SEWAGE DISPOSAL SYSTEM

MARYLAND STATE DEPARTMENT OF HEALTH

SUBDIVISION Moody Property

LOCATION SURVEY

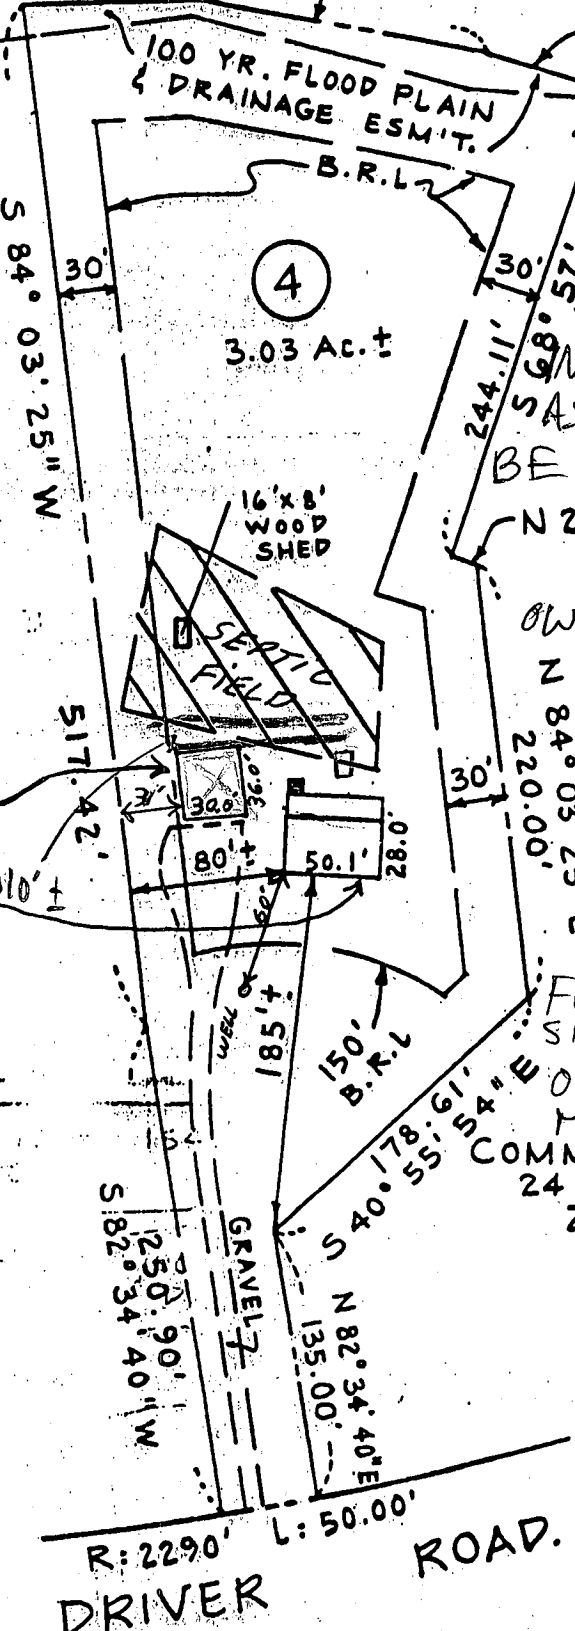
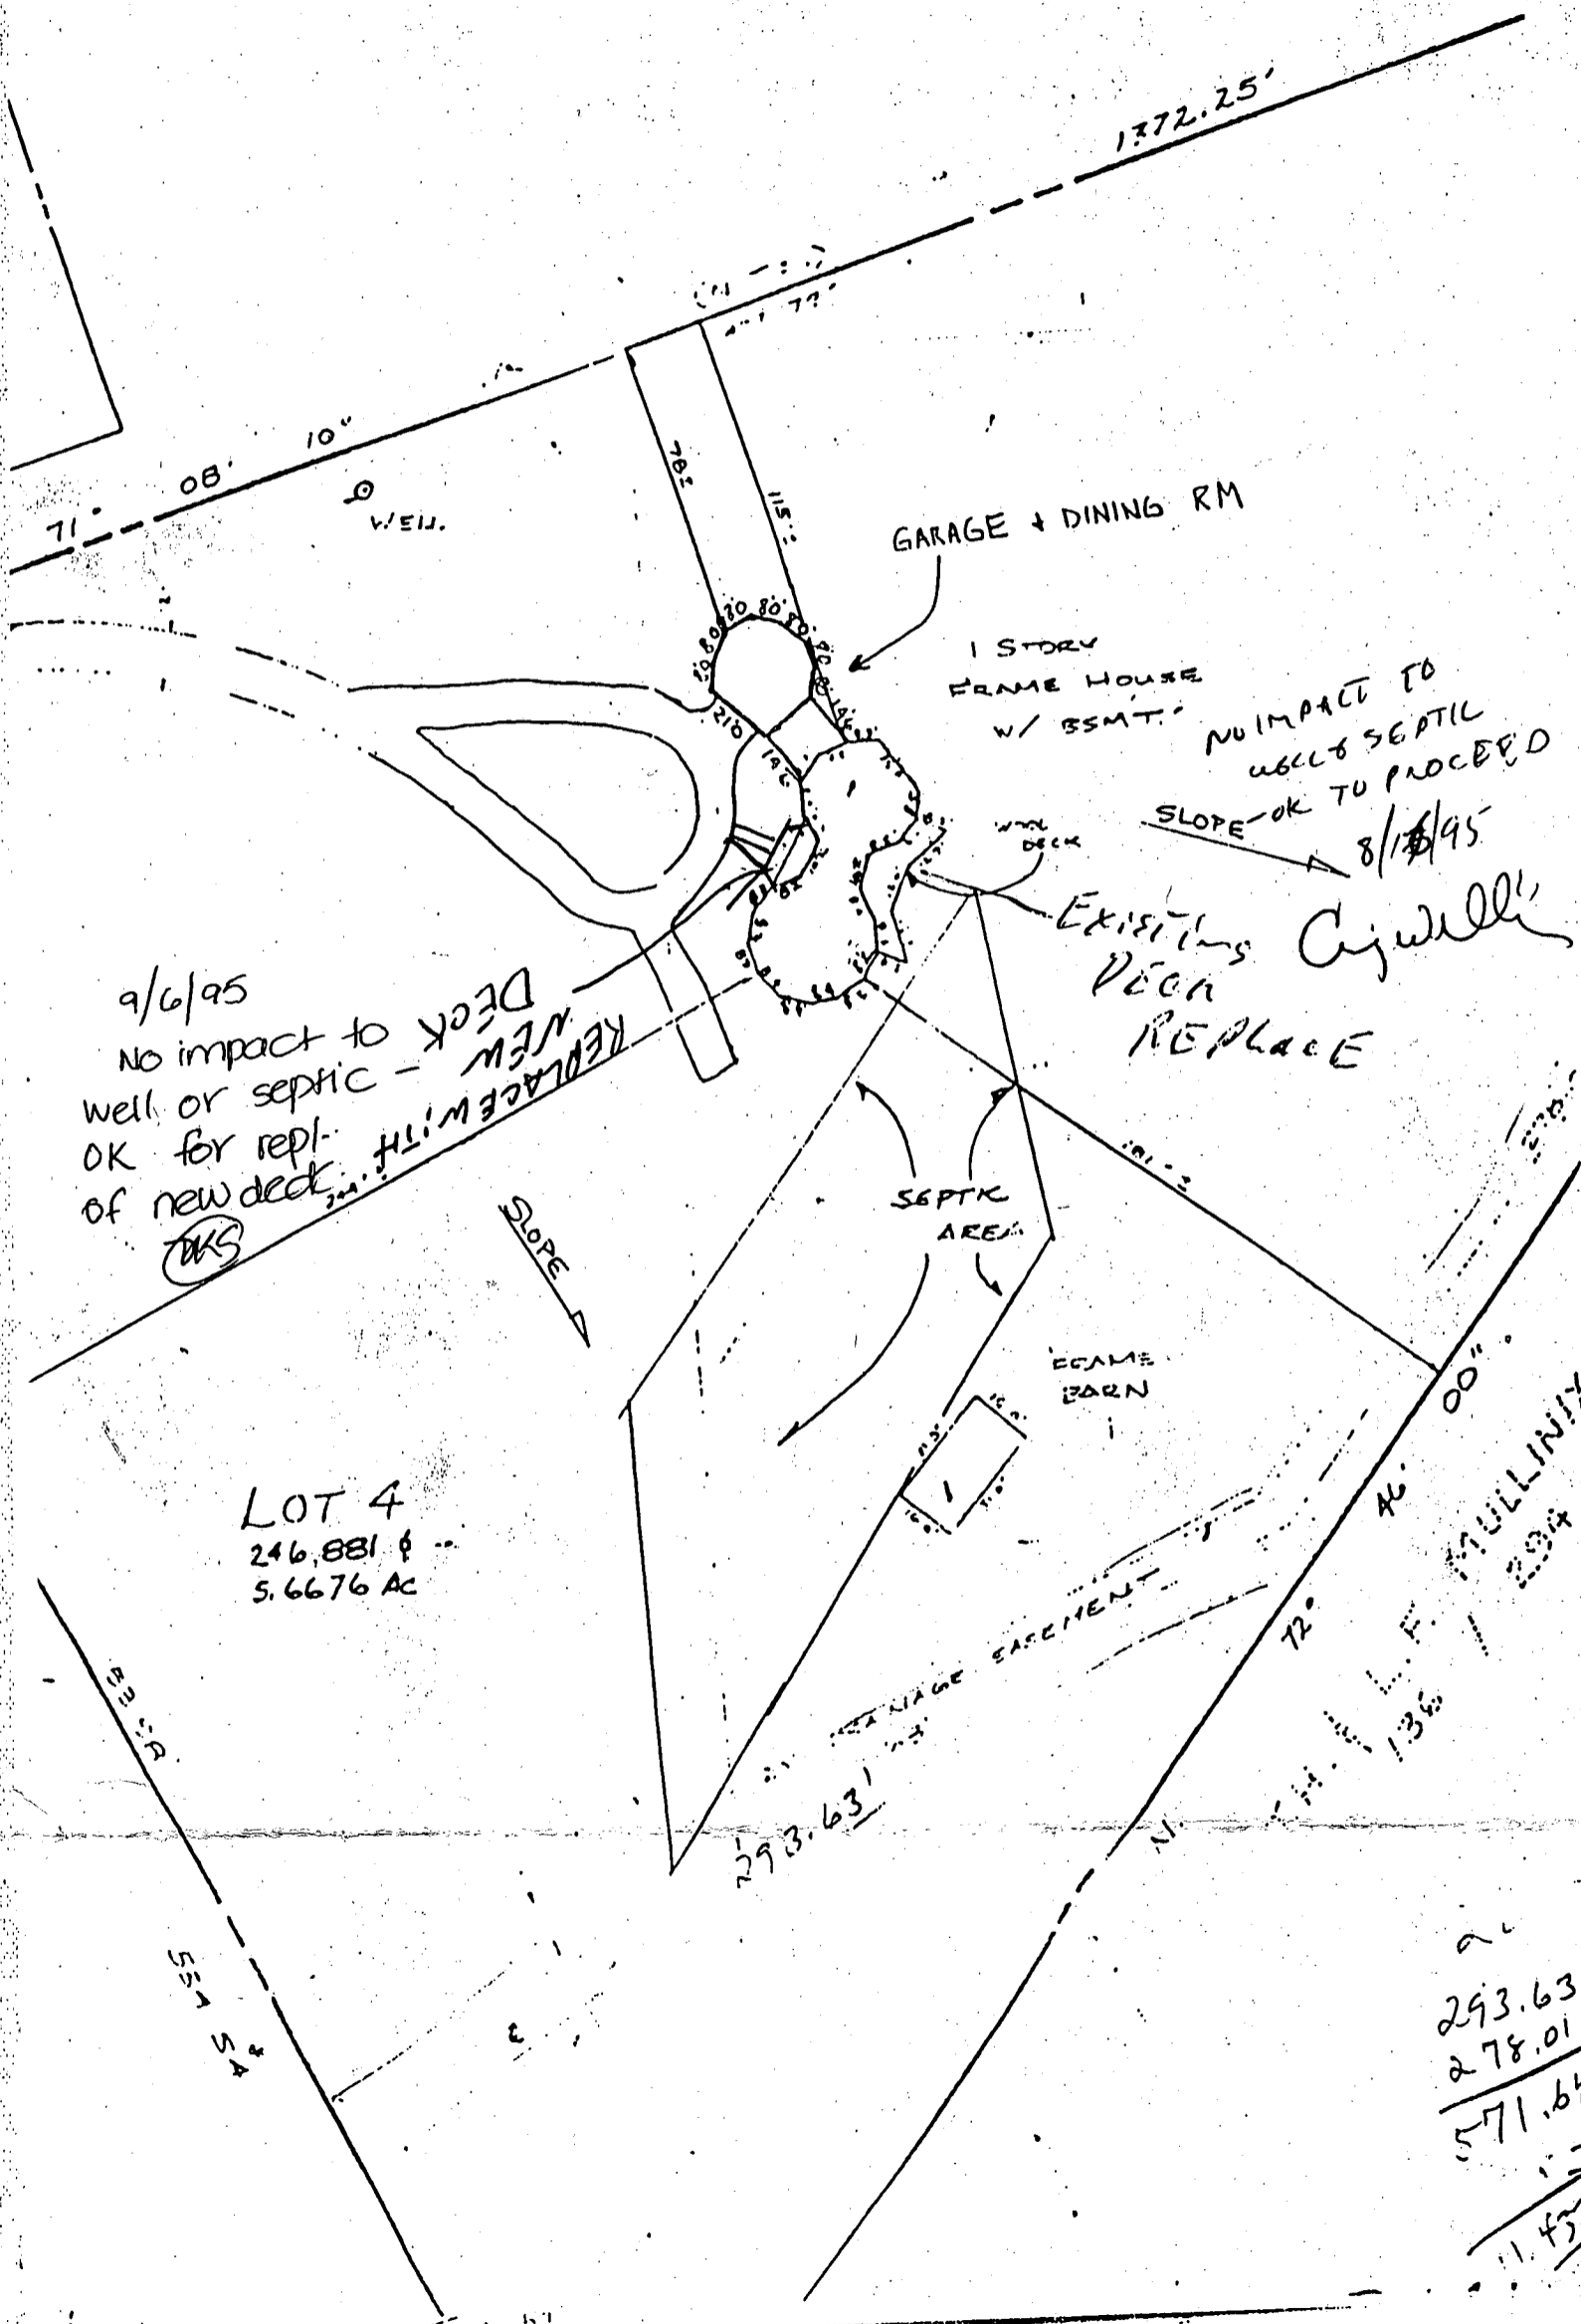
MEASUREMENTS
 AS PER
 SEPTIC DIAGRAM
 INDICATE BLDG.
 WAS PLANNED WOULD
 BE ON TOP OF
 HIGH TRENCH
 N 21° 02' 20" E
 15.54'
 OWNER TO CONFIRM
 HIGH TRENCH
 LOC. + CALL
 FOR INSP (MD)
 7/20/95
 BLDG MOVED
 FORWARD 10', OK TO
 SIGN UPON RECEIPT
 OF REVISED PLAN
 MR 8/30/95
 COMMUNITY PANEL NO.
 24 0044 0010 B
 ZONE "C"

9/6/95
 NO IMPACT TO
 WELL OR SEPTIC -
 OK FOR REPL.
 OF NEW DECK
 (MS)

NO IMPACT TO
 WELL & SEPTIC
 SLOPE OK TO PROCEED
 8/18/95
